The Commission has issued the enclosed Amendment No. 14 to Facility Operating License No. DPR-31 and Amendment No. 13 to Facility Operating License No. DPR-41 for Turkey Point Nuclear Generating Units 3 and 4. These amendments include Change No. 26 to the joint Technical Specifications and are in response to your request dated September 9, 1975, and Supplements dated October 29, November 21, and November 26, 1975.

ATTACHMENT TO LICENSE AMENDMENT NOS. 14 & 13  
CHANGE NO. 26 TO THE TECHNICAL SPECIFICATIONS  
FACILITY OPERATING LICENSE NOS. DPR-31 AND DPR-41  
DOCKETS NOS. 50-250 AND 50-251

SAFETY EVALUATION BY THE OFFICE OF NUCLEAR REACTOR REGULATION

TURKEY POINT NUCLEAR GENERATING UNITS 3 AND 4

Figure 2.1-1. Reactor Core Thermal and Hydraulic Safety Limits, Three Loop Operation

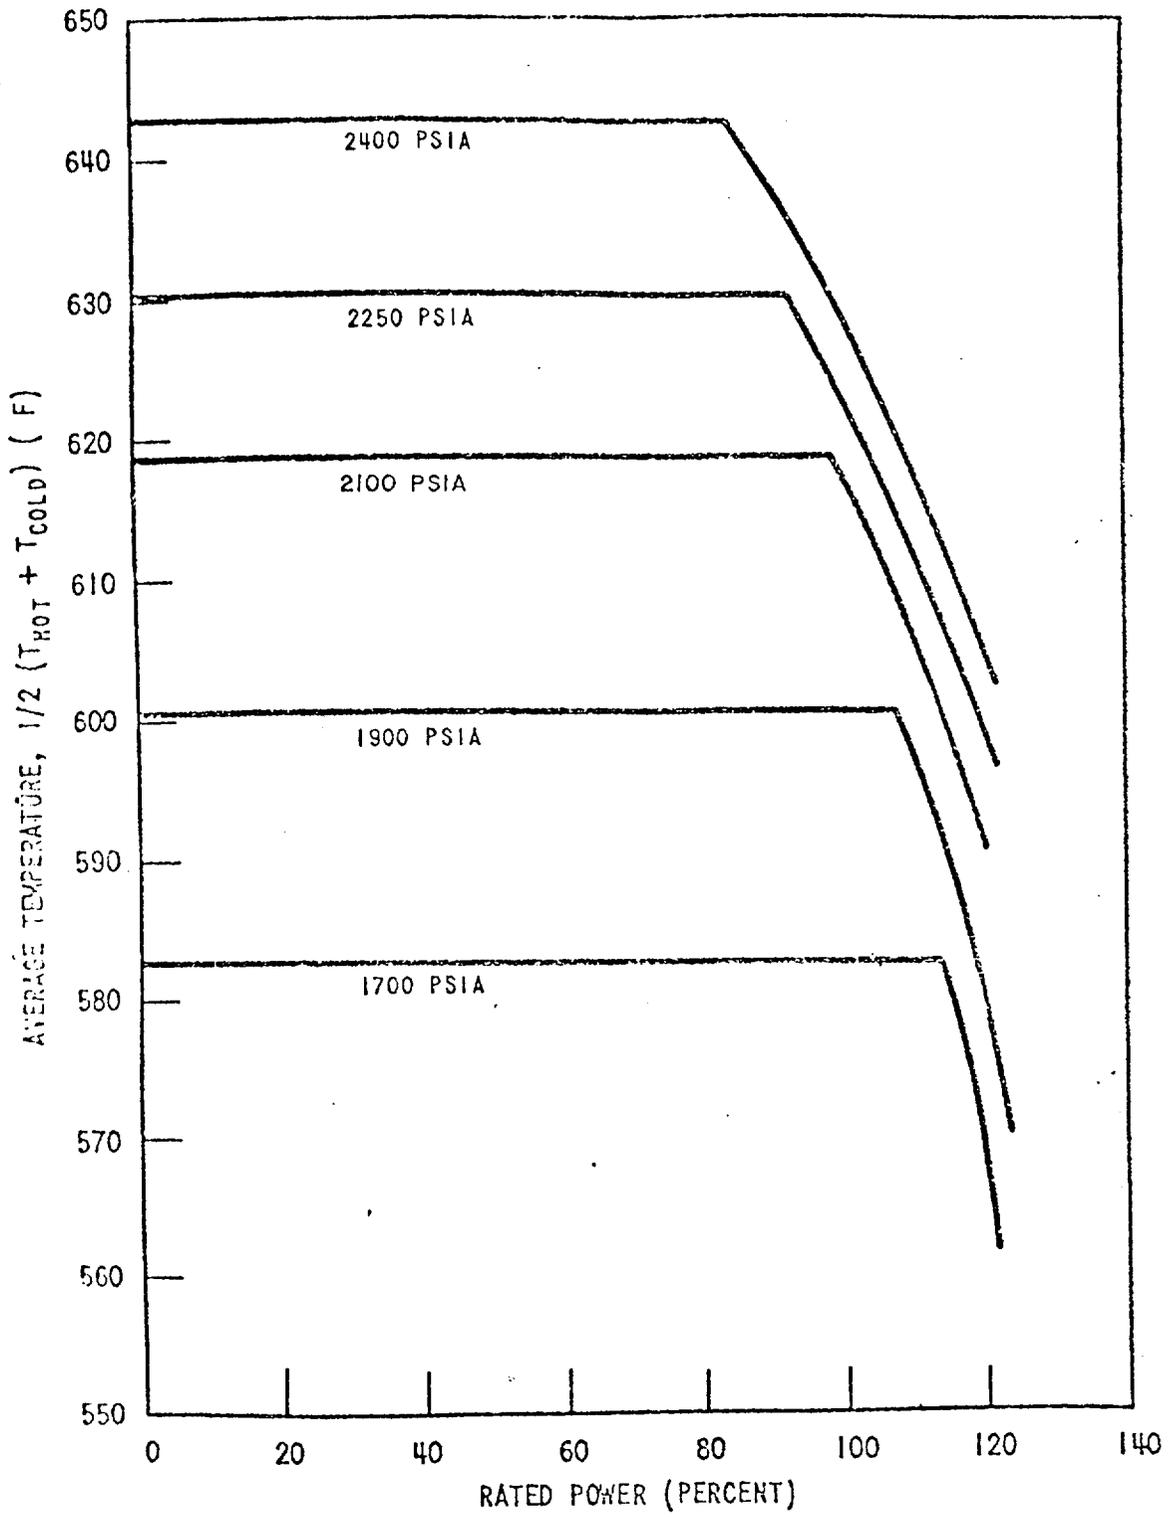
Replace page i, page v, page 1-6, Figure 2.1-1, page 2.3-2, page 2.3-3, page 3.2-1, Figure 3.2-1, Figure 3.2-1(a) and page B3.2-1 with the attached revised pages. Add page 3.1-7, Figure 3.2-1(b), Figure 3.2-1(c) and page B.3.2-1a.

In their submittal of November 21, 1975, FPL also proposed for inclusion in the Technical Specifications a revised Reactor Core Thermal and Hydraulic Safety Limit curve for three loop operation at 2100 psia. A similar curve for two loop operation at 2100 psia was not included in the Technical Specifications, at this time, because operation of the reactor with less than three reactor coolant pumps in operation is prohibited by the Technical Specifications.

FIGURE 3.2-1

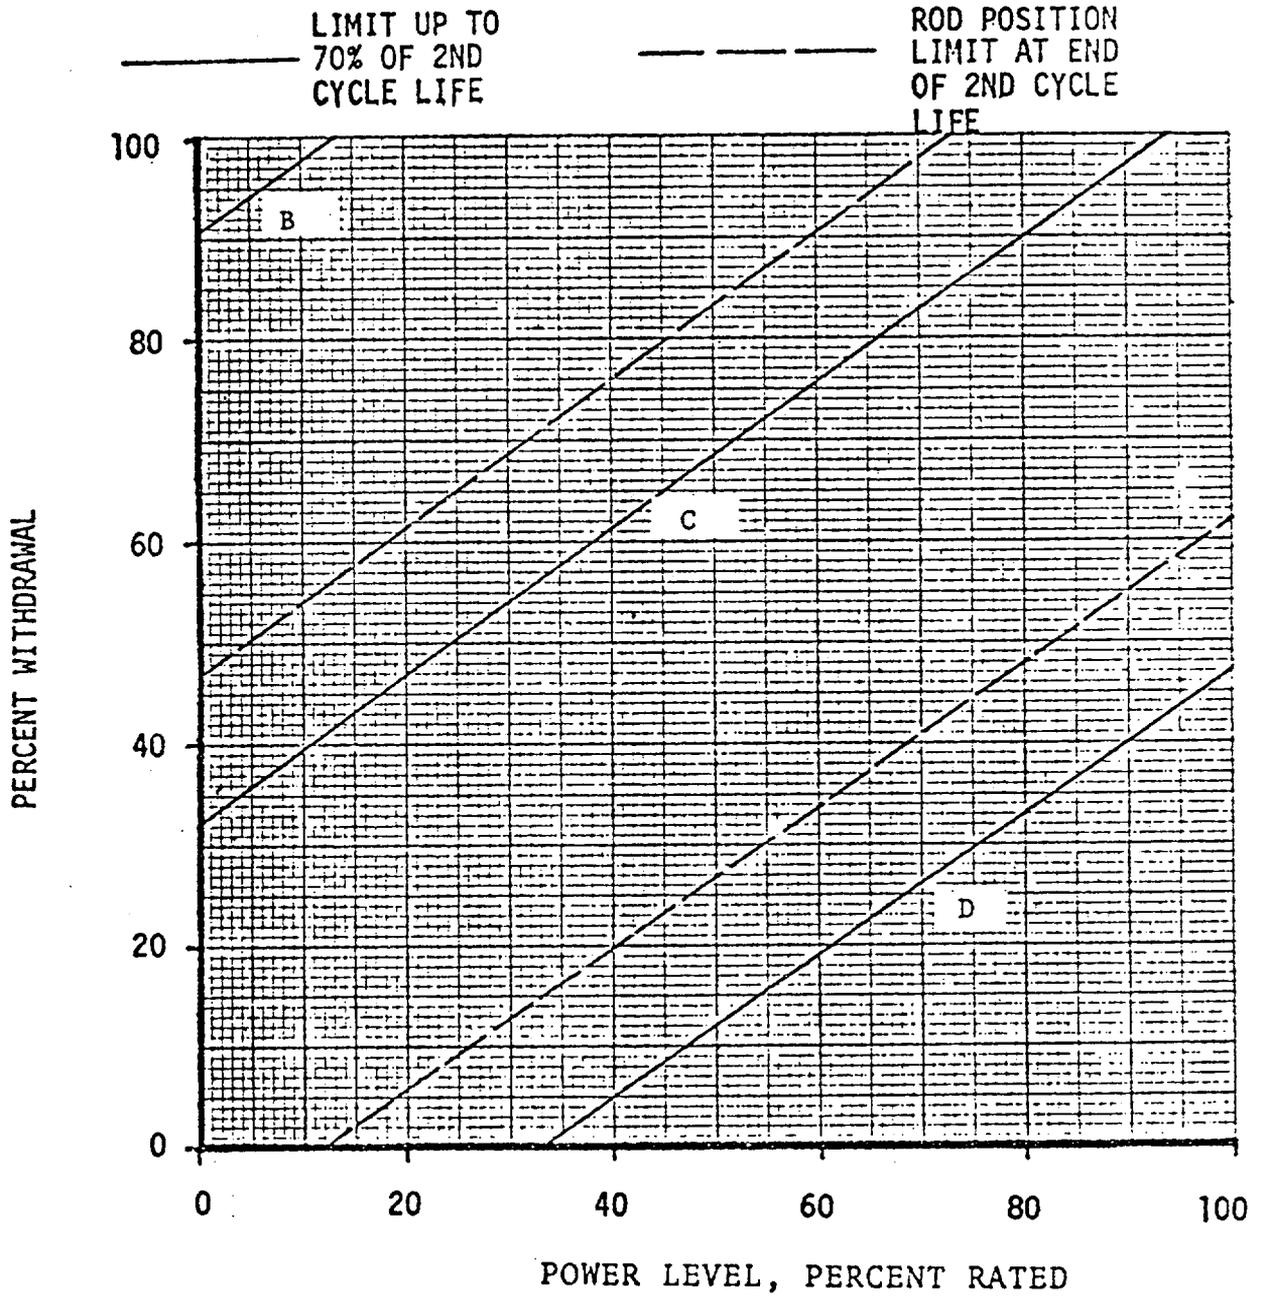
- c. For Unit 4, after 70% of the second and subsequent cycles as defined by burnup, the limits shall be adjusted as a linear function of burnup toward the end-of-core life as shown by the dotted lines on Figure 3.2-1. | 26

- d. The Unit 4, end-of-core life limit shown on Figure 3.2-1 and the Unit 3, control rod insertion limits shown on Figure 3.2-1(b) may be revised on the basis of physics calculations and physics data obtained during startup and subsequent operation. | 26

FIGURE 3.2-1(b).

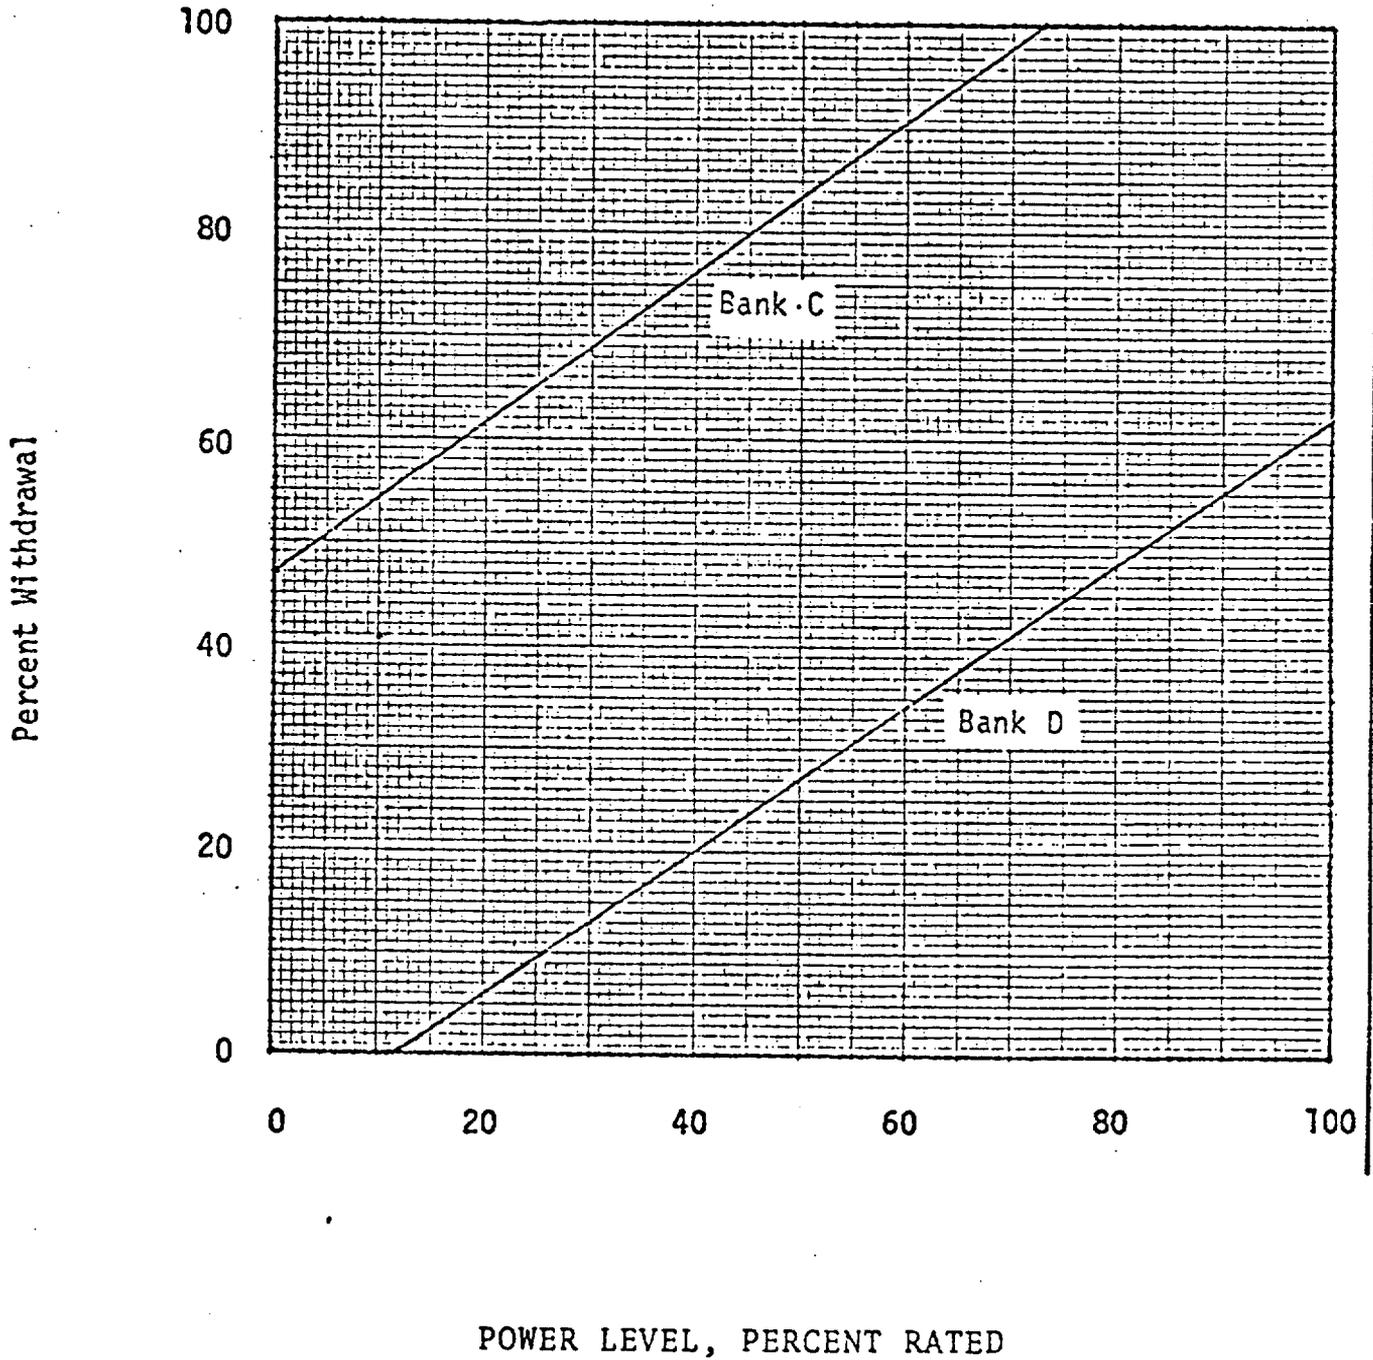
- a. Whenever the reactor is critical, except for physics tests and control rod exercises, the shutdown control rods shall be fully withdrawn.
- b. For Unit 4, whenever the reactor is critical, except for physics tests and control rod exercises, the control group rods shall be no further inserted than the limits shown by the solid lines on Figure 3.2-1 for three loop operation and on Figure 3.2-1(a) for two loop operation. Control rod insertion limits for Unit 3, are shown on Figures 3.2-1(b) and 3.2-1(c). | 26

FPL has analyzed the control rod insertion limits for three loop and two loop operation and has proposed Unit 3 control rod insertion limits

which are more conservative than those previously specified. The limiting constraint in defining the proposed control rod insertion limits is the maintenance of adequate shutdown margin at the end of core life. Use of the more conservative proposed control rod insertion limits will increase the minimum available shutdown margin, maintain an acceptable core power distribution, decrease the consequences of a control rod ejection accident and decrease the consequences of control rod misalignment. Moreover, since we find that the use of the proposed control rod insertion limits will not effect previously performed applicable safety analyses, we conclude that the proposed insertion limits are acceptable.
